ATTACHMENT A
AGENDA ITEM 6.1

Independent Planning Advice regarding Draft Permit Conditions for Planning Application DA-2023-58 for Storage (Warehouse) at 1 Letitia Grove, Bridgewater

PLANNING PERMIT (DA 2023 / 00058)

1 Letitia Grove, Bridgewater
Certificate of Title Volume 40199 Folio 1

1,125 NORTH & SOUTH ELEVATIONS DRAWING NO 23020/3A

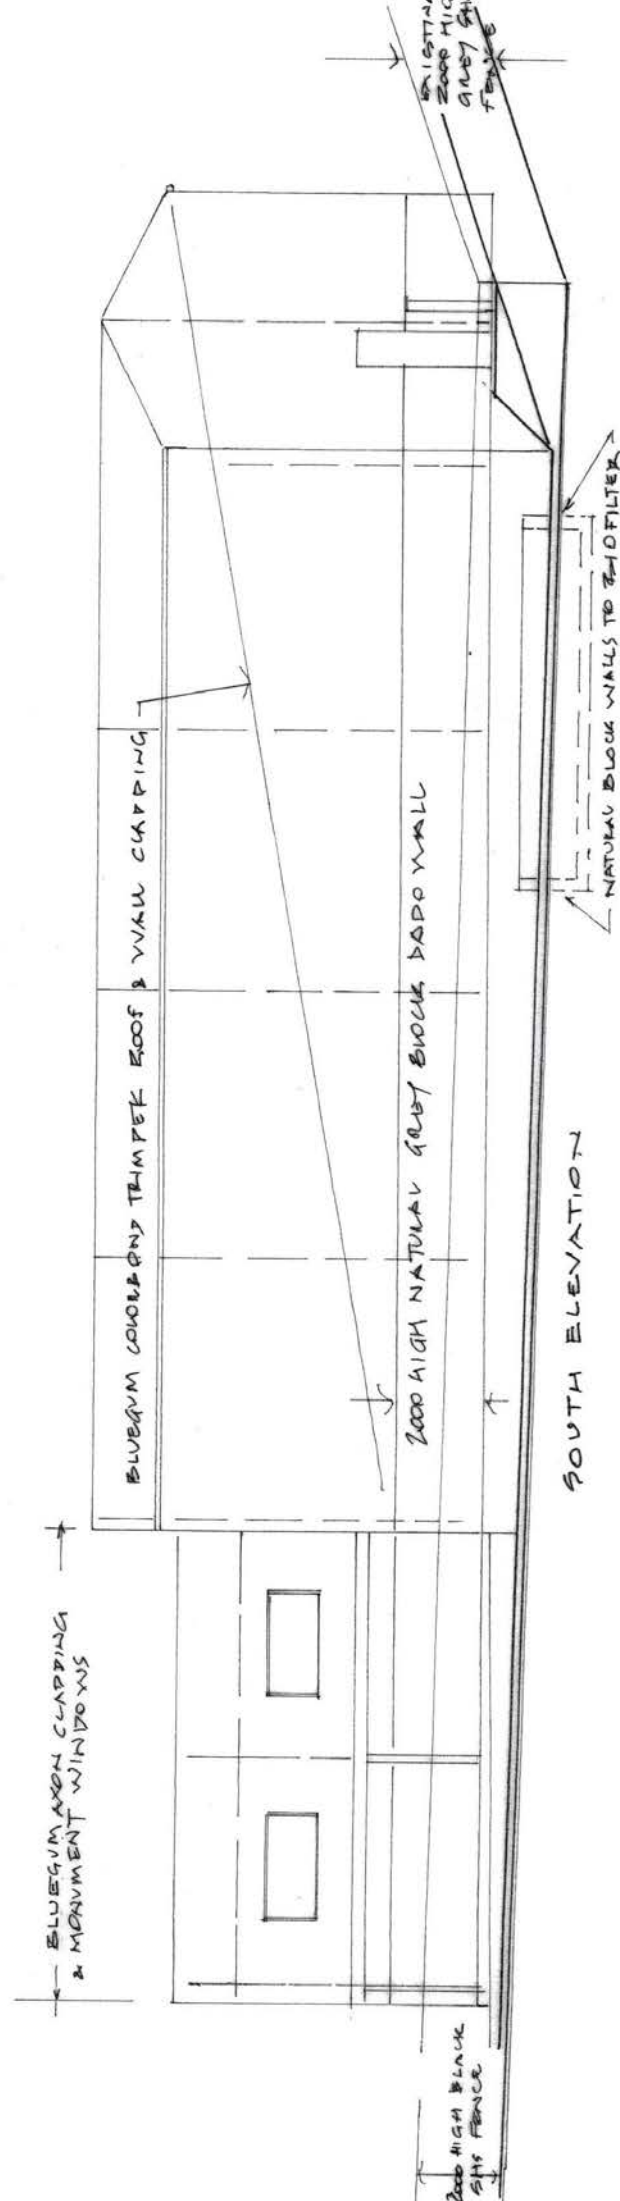
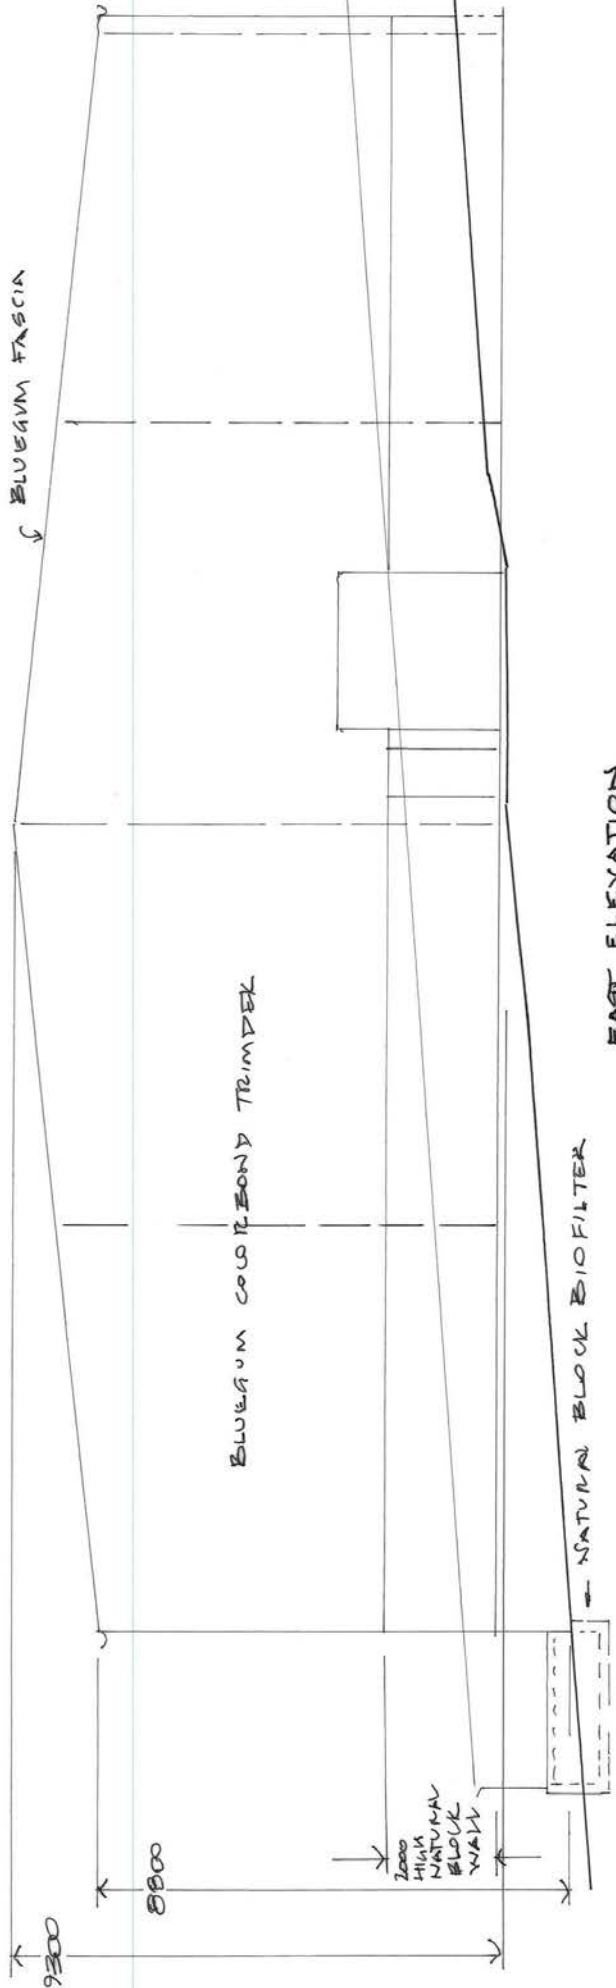
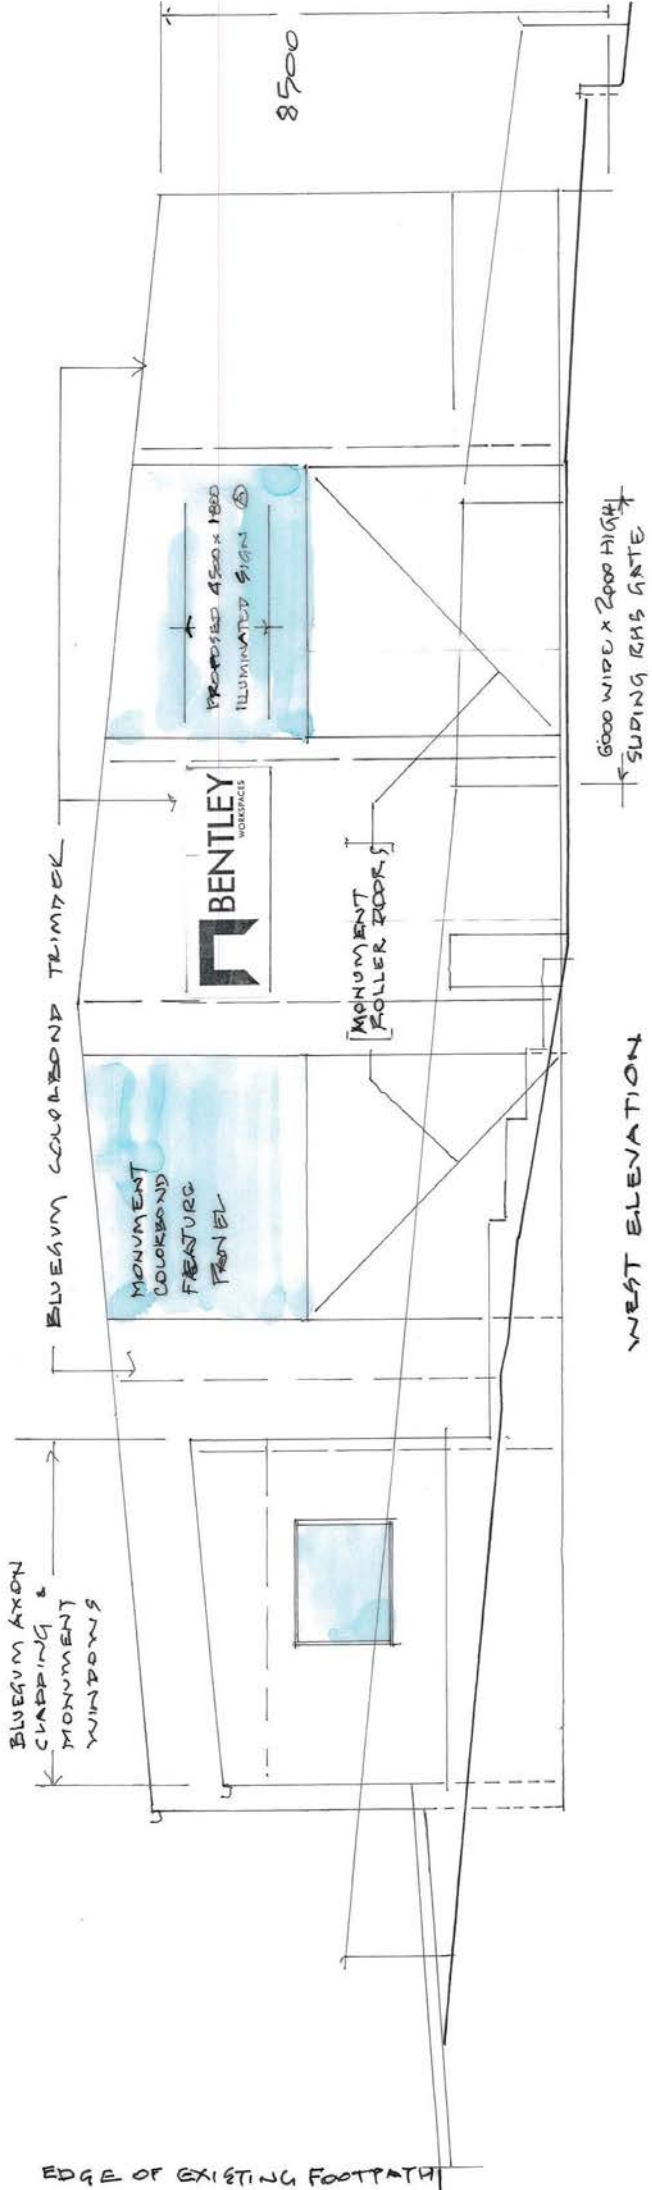
- 4) The proposed colours and materials for the walls and roof as shown on Elevation Drawing no. 23020/3 and Drawing No 23020/4 are approved. Any variation in the colours and materials must be submitted to and approved by the Council's Director Development Services.

PROPOSED WAREHOUSE
 1 LETITIA GROVE
 BRIDGEWATER
 1:170 STORMWATER
 PLAN
 FOR CQJ PROPERTIES
 DRAWING 25020/11A

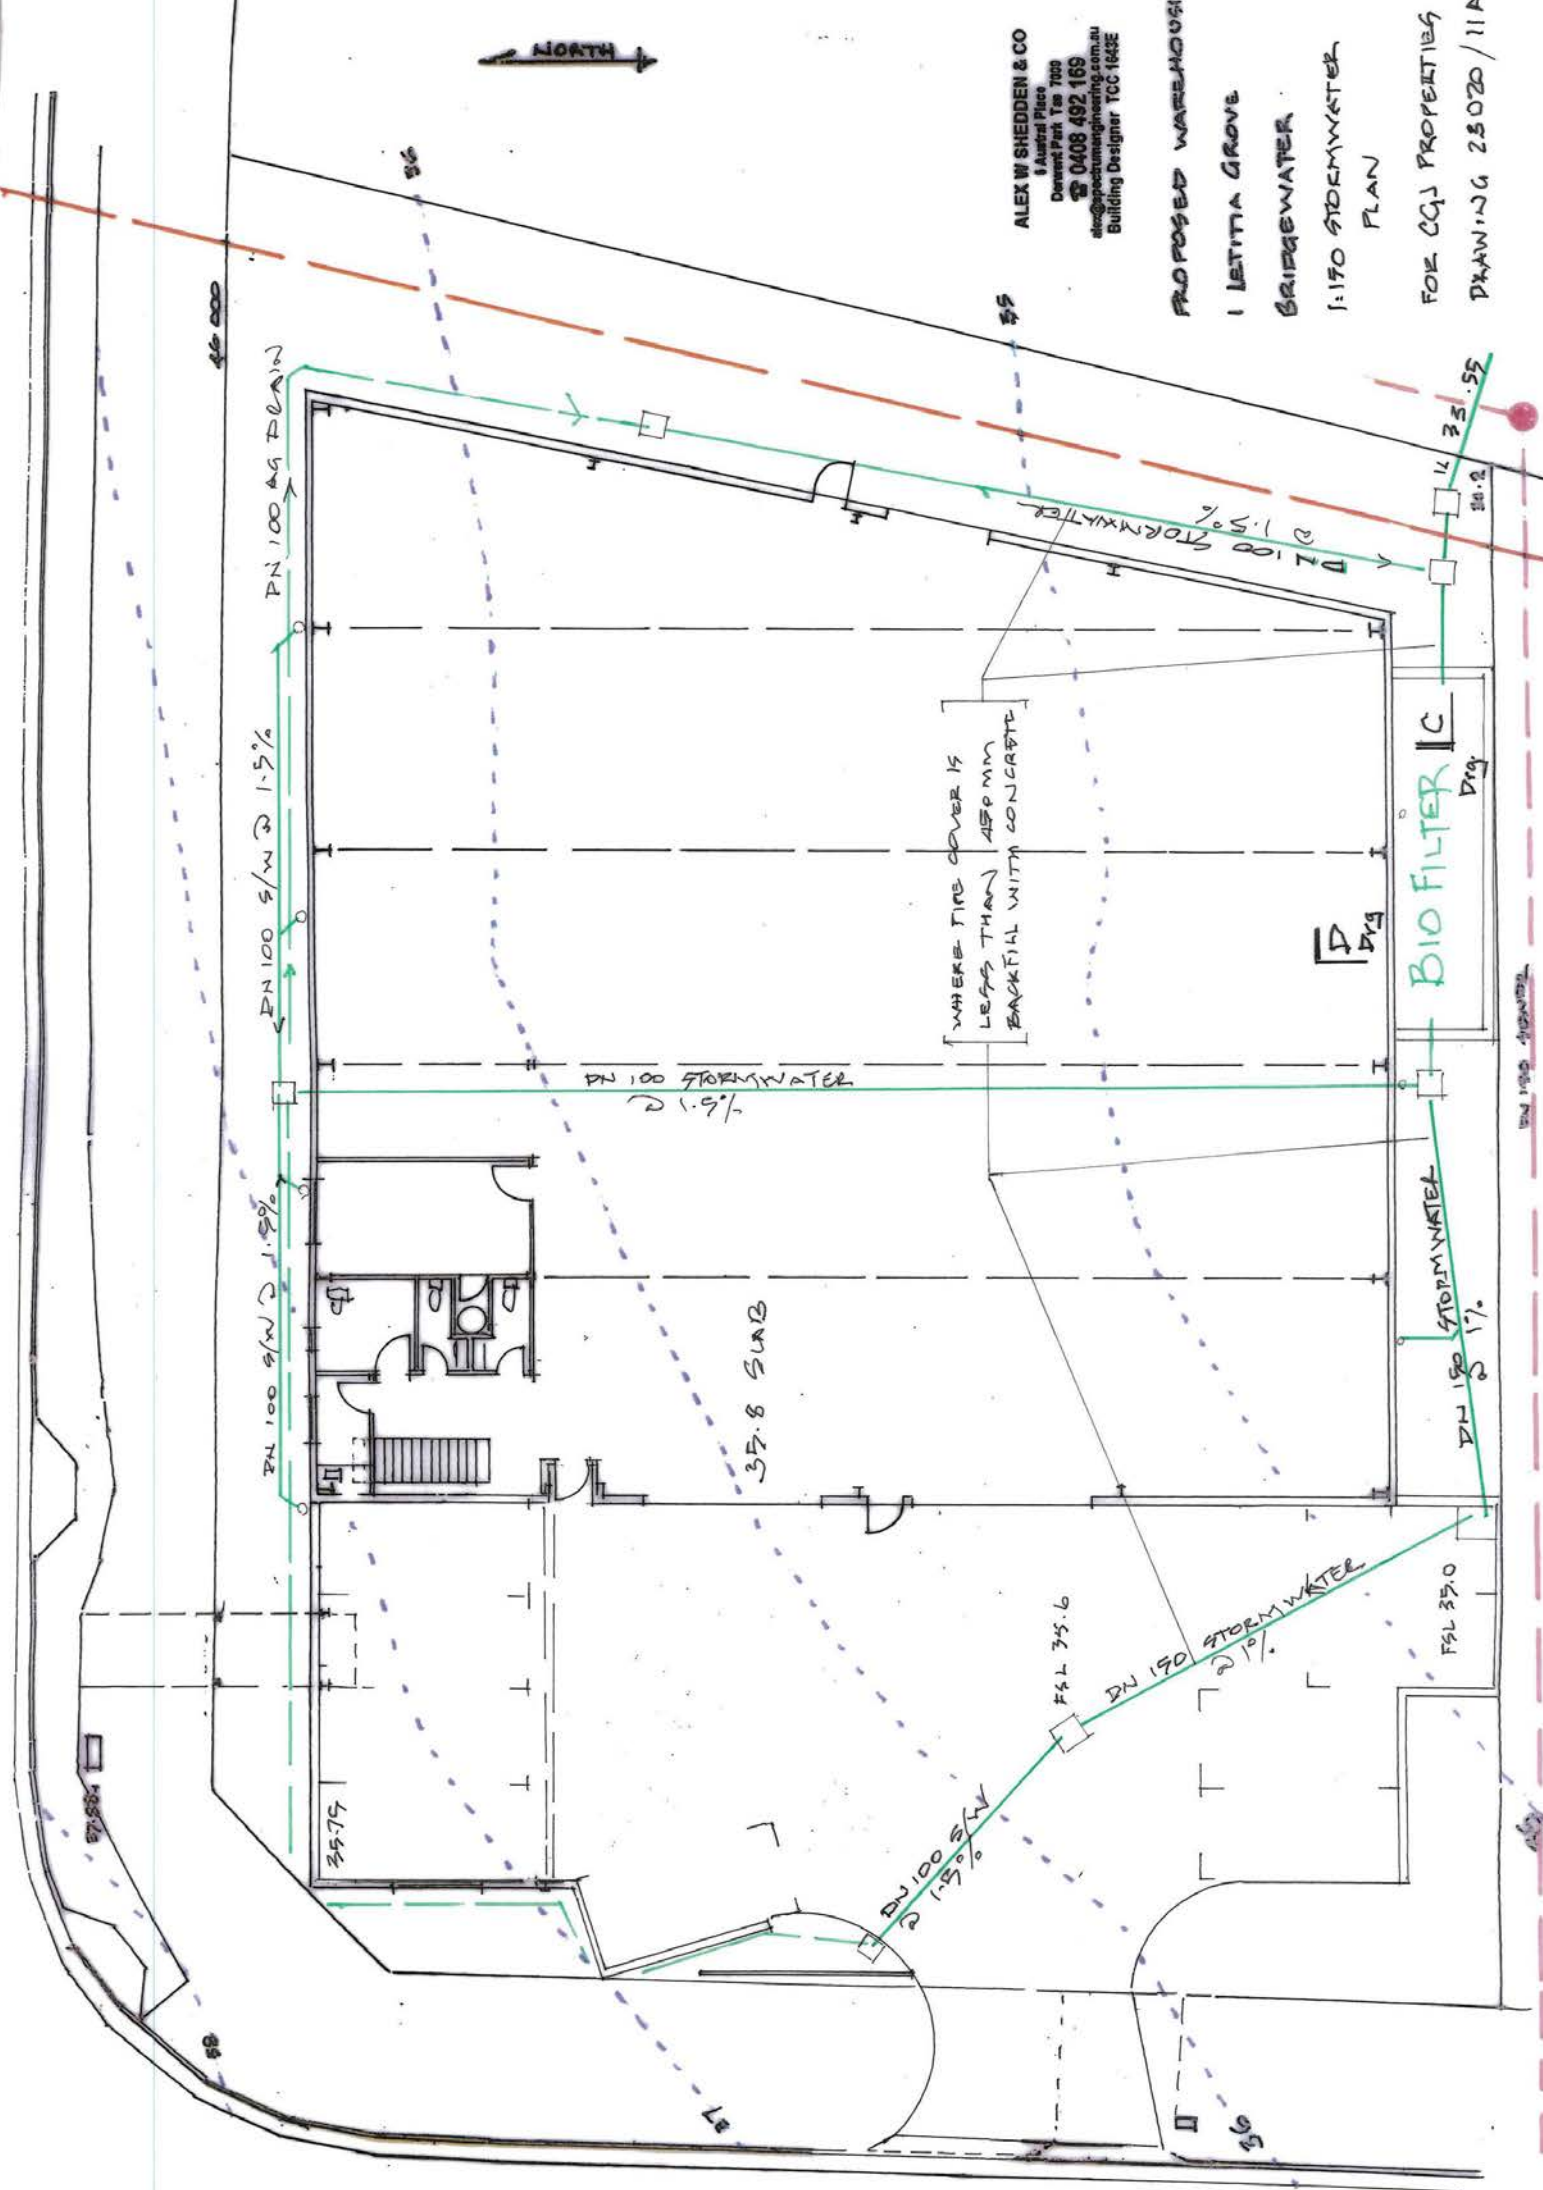
The only recommendations I have relates to Condition 23 on the draft permit. Firstly, I recommend that Condition 23 on the draft permit is amended to state that the required 'Stormwater Management Report' *must be to the satisfaction of Council's Municipal Engineer*. This is to ensure that this report when submitted by the developer is of a standard and content satisfactory to Council's engineer given that an approved Stormwater Management Plan will form part of approved and enforceable permit requirements.

I also recommend that the required 'Stormwater Management Report' referenced in Condition 23 is instead referenced as a 'Stormwater Management Plan' in the entirety of the condition to avoid confusion. Currently the condition as drafted refers to it as both a plan and report.

- 23) Prior to the commencement of works the developer must submit a Stormwater Management Plan to the satisfaction of Council's Municipal Engineer. The Stormwater Management Plan must be prepared and certified by a suitably qualified person, in accordance with section 2.6.2 of *DEP & LGAT (2021). Tasmanian Stormwater Policy Guidance and Standards for Development. Derwent Estuary Program and Local Government Association of Tasmania (Hobart, Australia)* and include calculations, design, construction and maintenance details of stormwater treatment, detention, and conveyance. The plan must clearly demonstrate that the requirements of this permit are met and that adjacent properties will not be adversely impacted by the stormwater system. Once approved the Stormwater Management Plan will form part of this permit.
